ITEM TITLE: PC 23 08 DR 02 – *Dollar General Design Review*

RESOLUTION PC 23 08 DR 02

A REQUEST FOR DESIGN REVIEW OF A 10,640 SQUARE FEET RETAIL STORE AND ASSOCIATED IMPROVEMENTS ON AN UNDEVELOPED ONE ACRE PARCEL AS SHOWN ON ASSESSOR'S MAP # 18-12-23-22, TL 06800 LOCATED AT THE NORTHEAST INTERSECTION OF HIGHWAY 101 AND 36TH ST.

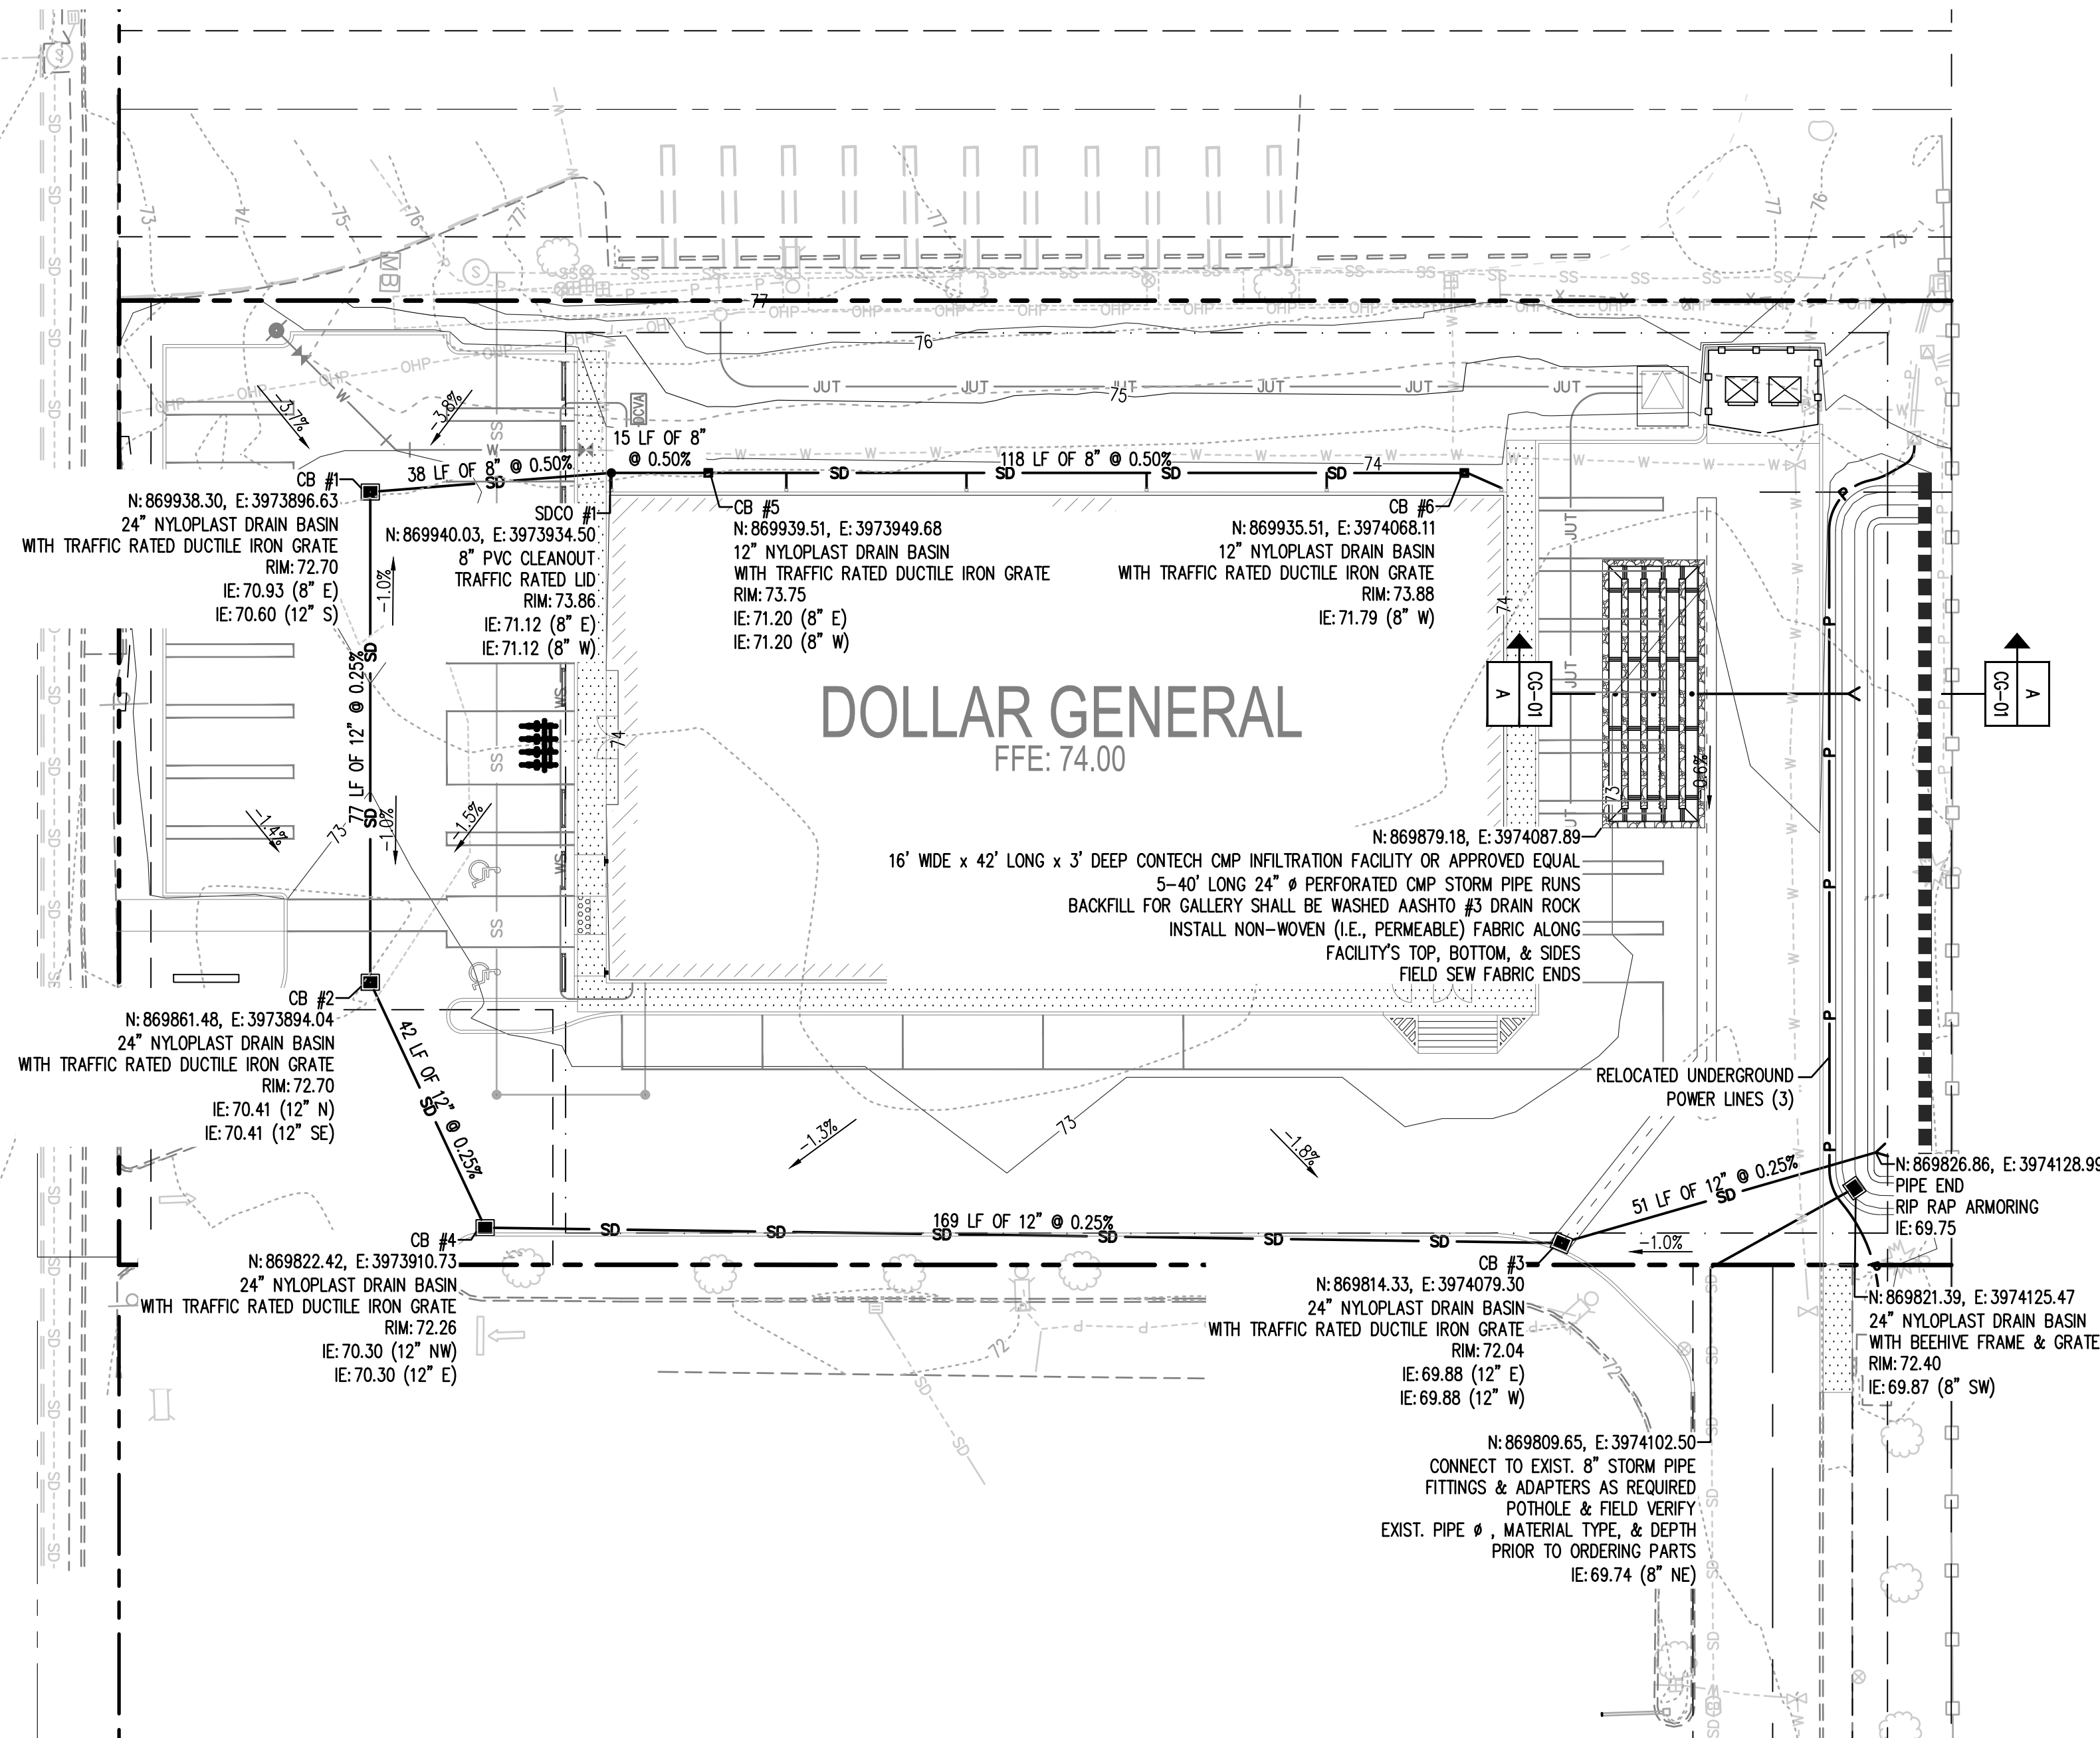
- 4-1. Required parking spaces shall be maintained and shall not be eliminated, used for the storage of materials of any type, or used for loading or unloading operations during business hours.
- 4-2. Per FCC 10-3-8, parking areas shall be graded so as not to allow storm water to drain over public sidewalks.
- 4-3. In accordance with FCC 10-4-8 G, fencing and evergreen hedges must be well kept and maintained.
- 4-4. A detailed and dimensioned signage plan that meets requirements outlined in FCC Title 4, Chapter 7 shall be submitted and approved by the Florence Building Department.
- 4-5. Per Table 10-3-3 under FCC 3-9-F, the applicant shall submit a parking plan to

revise the measurements of the 2 (two) required ADA parking stalls from 8' widths to 9' widths.

With 31 total parking spaces proposed, the proposal requires two accessible parking spaces, including at least one van-accessible space. The applicant proposes two accessible parking spaces, one on either side of a van-accessible access aisle, measuring slightly more than 96 in. in width. Provided signage details shown on Sheet SP-01 of Exhibit C meet the requirements of Florence City Code and the Americans with Disabilities Act. These criteria are met.

- 32 spaces provided. Please correct sheet LS-01 for consistency.
 - Sheet SP-01 indicates 32 parking stalls provided
 - LS-01 indicates 23 parking stalls provided

- Specification of curb cut dimensions, both Hwy and adjacent properties if applicable.
 - Site illumination does not meet code. If parking lot lights are proposed to meet minimum illumination levels please include specifications of location, height, and fixtures on sheet SP-01 and the photometric plan.

- Sheet SP-01 has been revised to include 31 parking spaces. LS-01 has been updated to match the number of stalls provided.
 - **10-3-5-E:** Please provide examples of all ADA accessible parking signage on the parking plan.

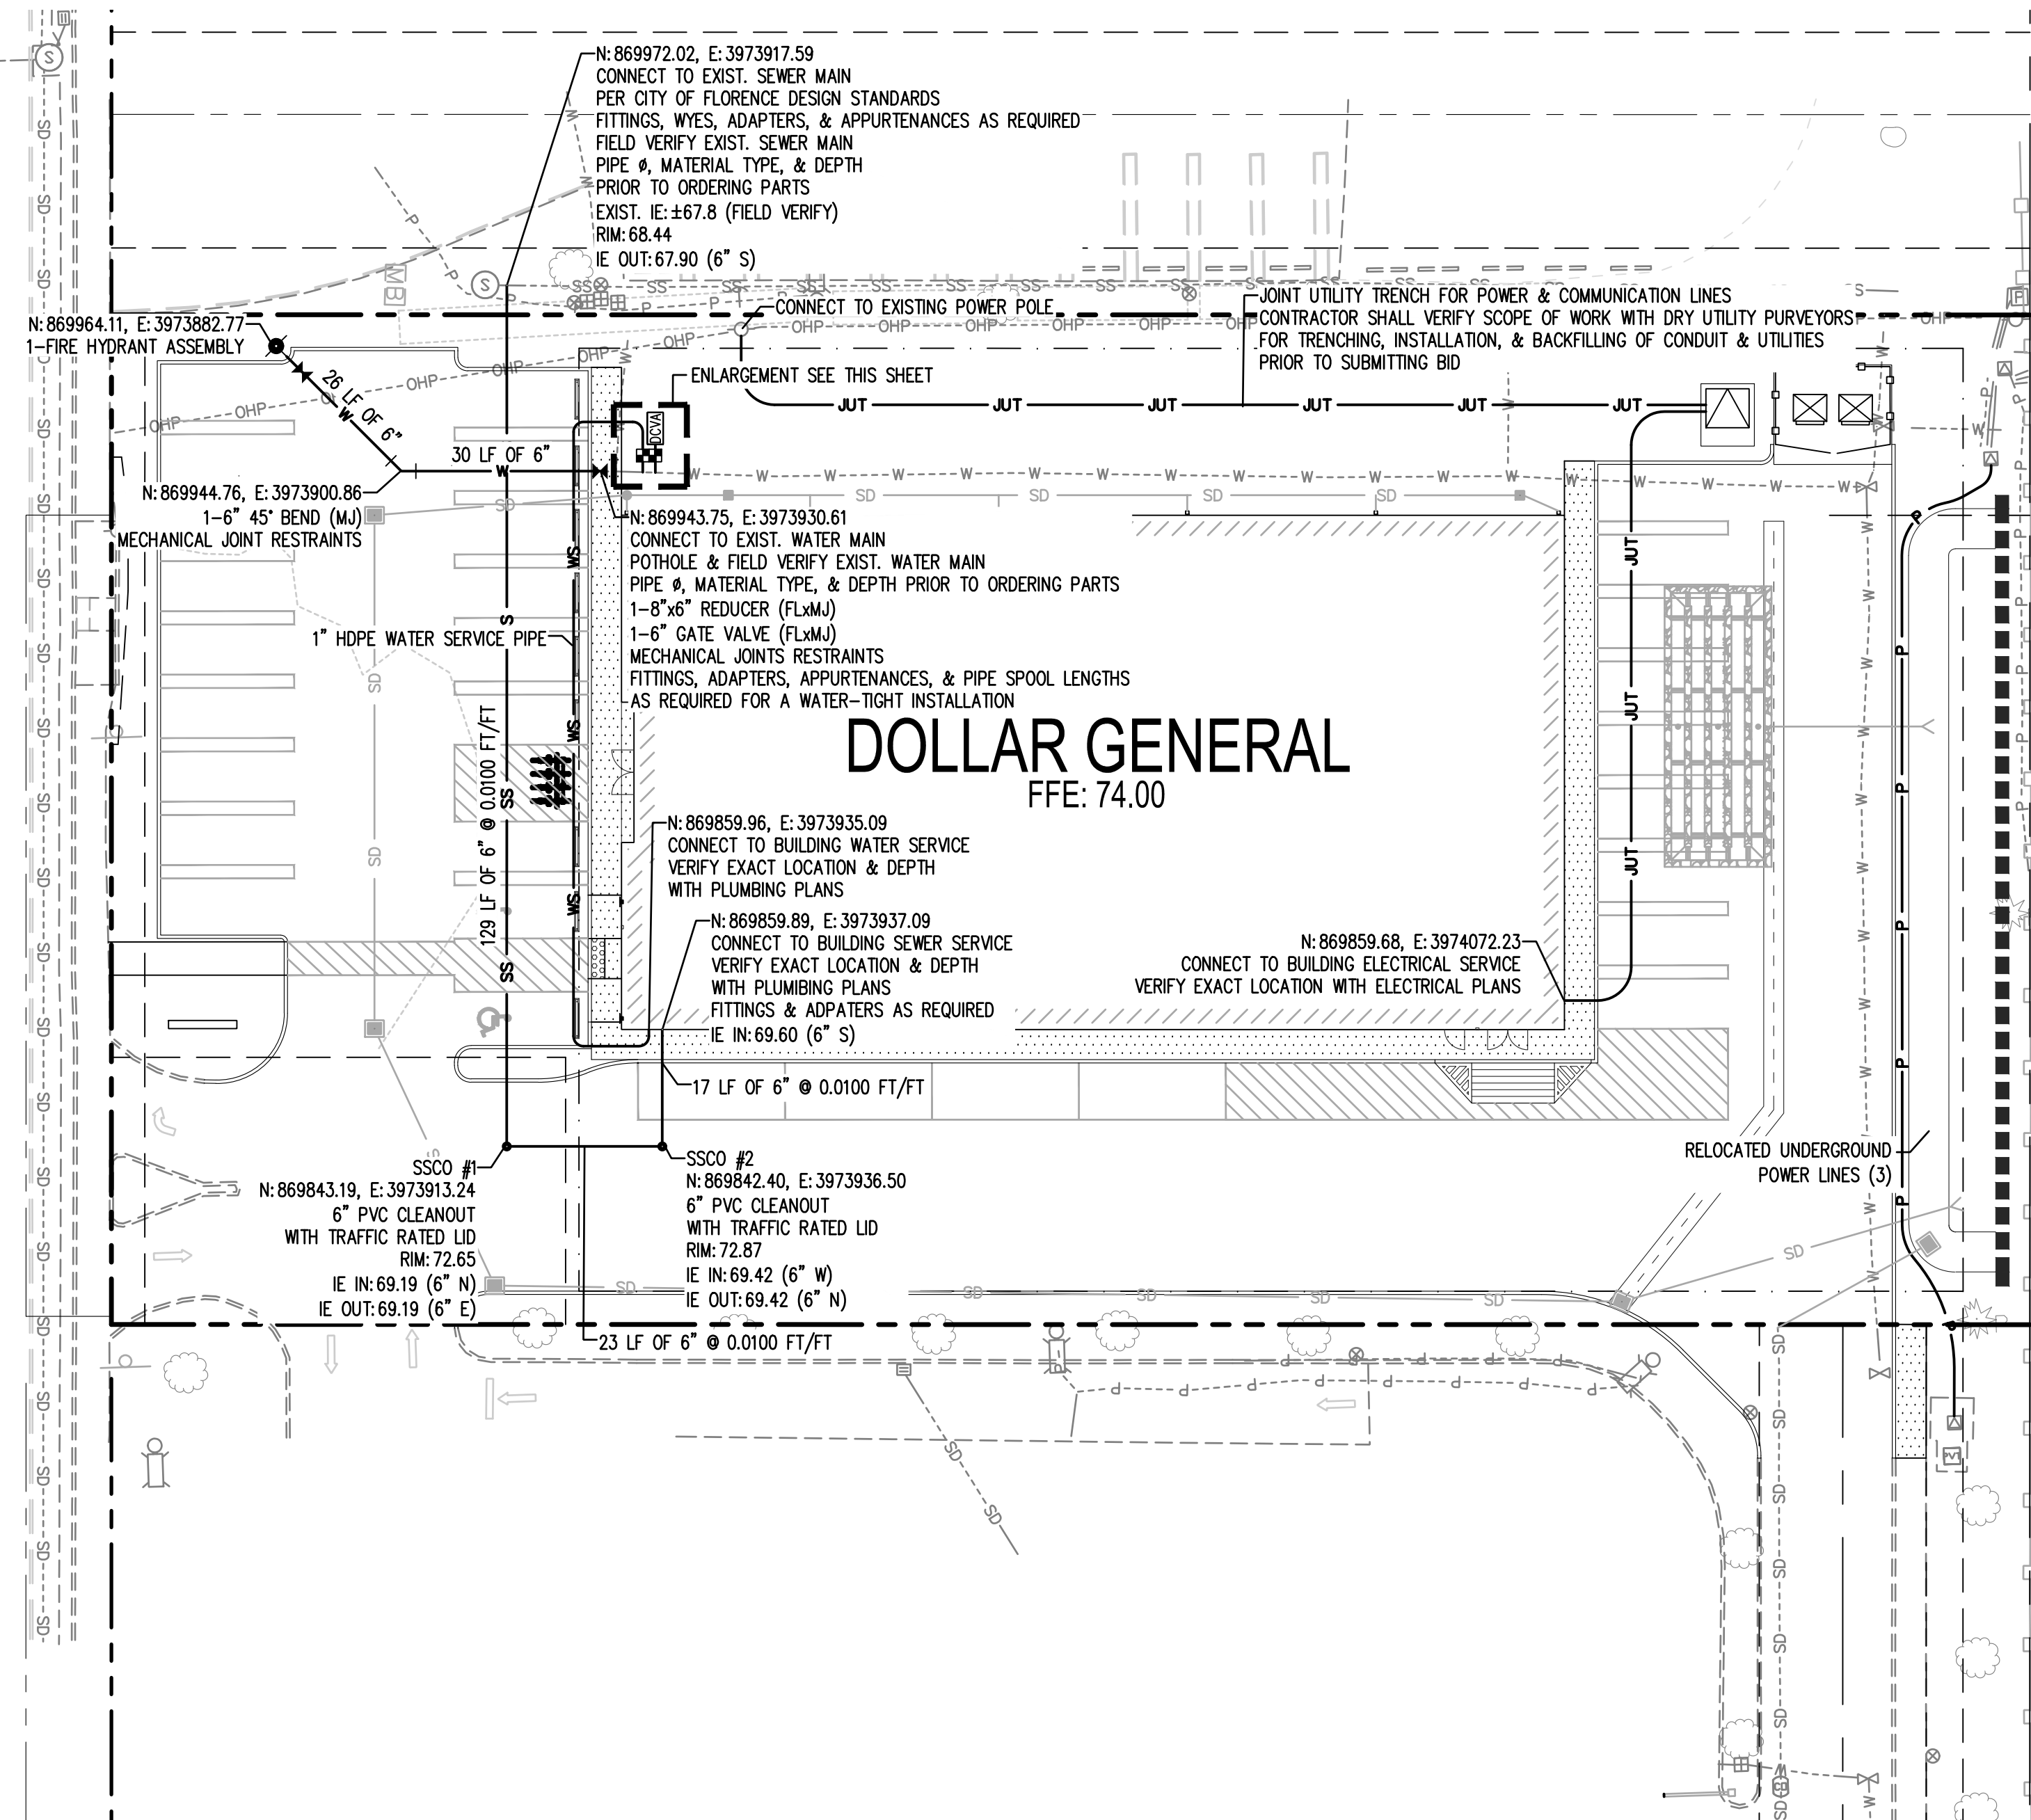
The applicant has provided a diagram with Slough Sledge included in what the Stormwater Report in Exhibit H explains is an at-grade infiltration rain garden and shown on Sheet CG-01 of the Site Plan in Exhibit C on the east side of the subject site, however, the rain garden itself is not marked on the Landscape Plan. The design of stormwater facilities are shown on Sheet CG-01; but not detailed in the Landscape Plan. Slough Sledge is just one of many plants recommended for rain garden facilities and are found in Appendix G of the Florence Stormwater Design Manual. A revised stormwater plan has been conditioned elsewhere.

Note 14 of the preliminary site plan on Sheet SP-01, Exhibit C, refers to the rain garden as a storm retention pond. Both facilities are structured differently. The City's Stormwater Design Manual provides an explanation on rain garden and requirements beginning on page 28 of 49 of the Stormwater Design Manual. Within the submitted materials to the Planning Department, details are lacking regarding growing/filtering media (again, per the Stormwater Design Manual), construction and materials for the rain garden such as permeable linings.
